**FIRST AMENDMENT
TO THE
DRAFT
ENVIRONMENTAL IMPACT REPORT
FOR THE
GENERAL ELECTRIC FACILITY
PD REZONING**

**City File # PDC04-029
State Clearinghouse # 2004062104**

CITY OF SAN JOSÉ

June 2005

Figure 1

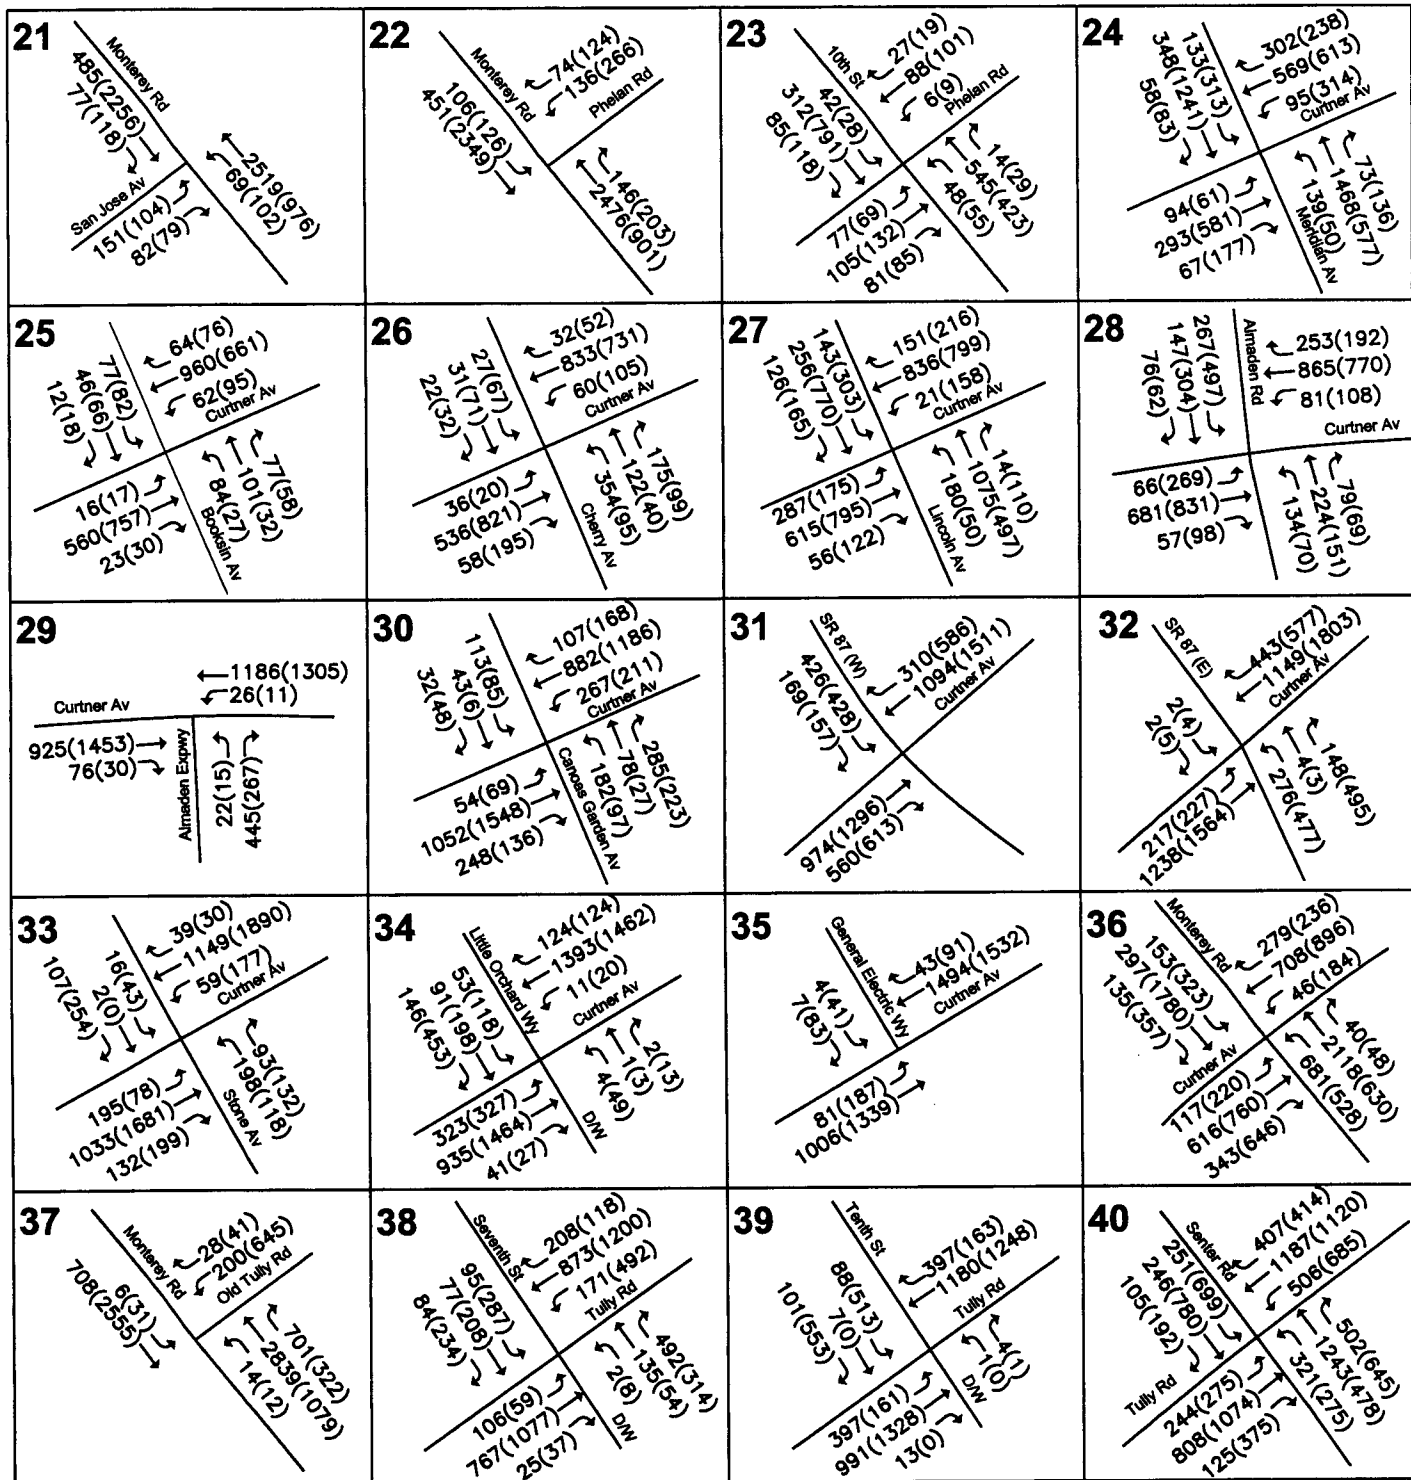
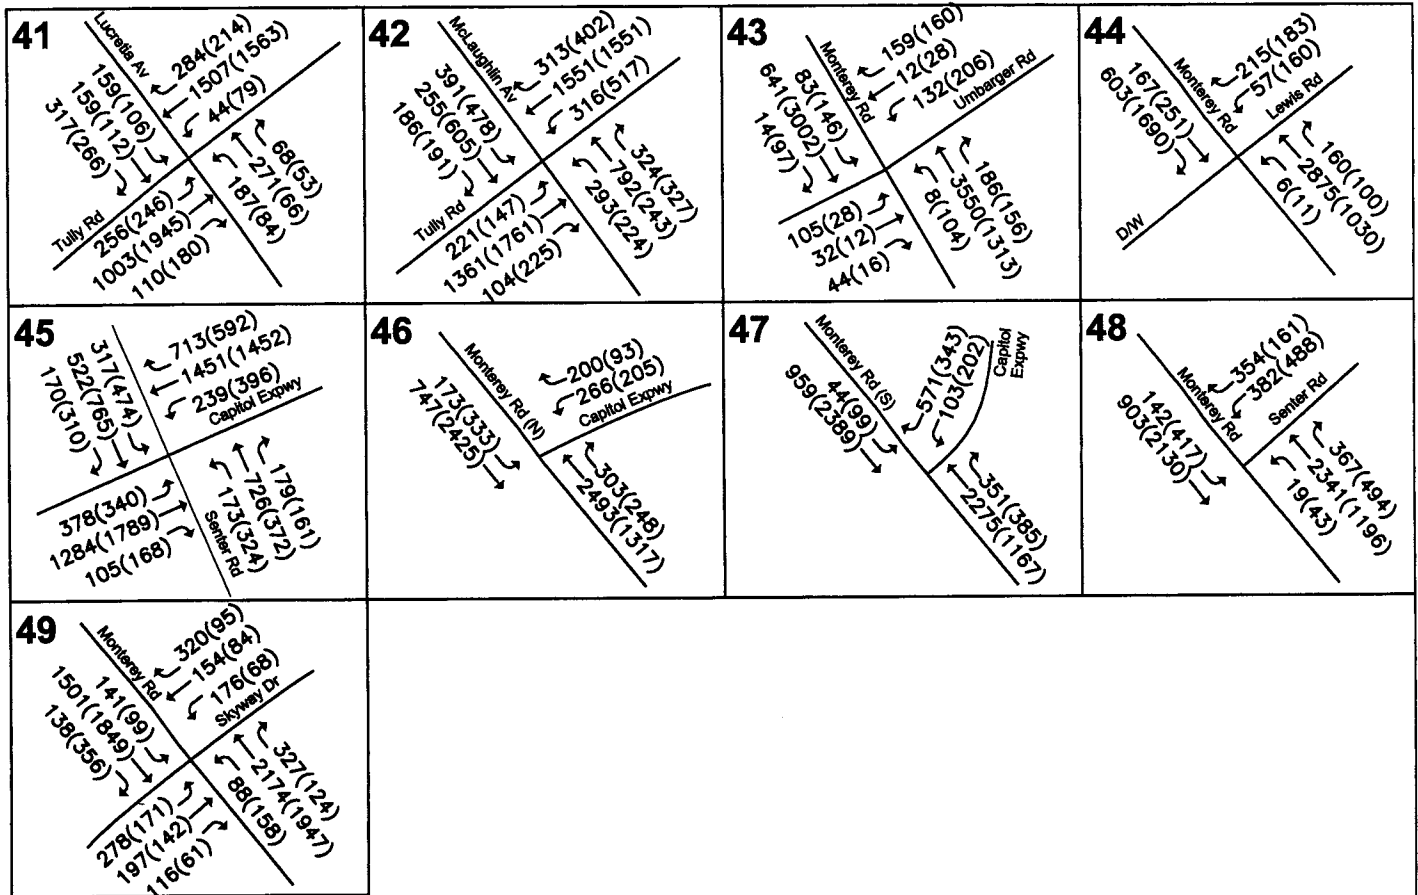
We would like to know why cumulative traffic volumes in Figure 19 at sampled intersections 31, 32, 34, 35 and 36 adjacent to project site are almost the same as those under project option 1 conditions in Figure 13 and project option 2 conditions in Figure 17. Does the Cumulative Condition include project options 1 and 2? If not, the report should evaluate Cumulative Plus option 1 and Cumulative Plus option 2 conditions.

A4: The cumulative scenario has been revised in this Final EIR to incorporate a third project, the Goble Lane Mixed Use Project (refer to Section 3 of this Amendment). The revised cumulative traffic volumes are presented in this Amendment in Attachment 1. Inclusion of the Goble Lane project did not change the conclusion of the cumulative analysis. In regards to your specific comment, the reason that the volumes in the original cumulative analysis were low was due to the relatively few trips generated by the original two projects and the orientation of these trips away from the project site. Only Option 2 is considered in the cumulative analysis, because it represents the worst case scenario in terms of traffic volumes.

The traffic volumes associated with these developments were obtained from the traffic reports prepared for these developments. Traffic volumes for cumulative conditions were estimated by adding traffic associated with these pending developments to the background plus Project Option 2 (Commercial plus Cineplex) traffic volumes. Project Option 2 (Commercial plus Cineplex) was selected to represent the project component of Cumulative Conditions because it is the project option that represents worst-case conditions. Cumulative traffic volumes are shown on Figure 1.
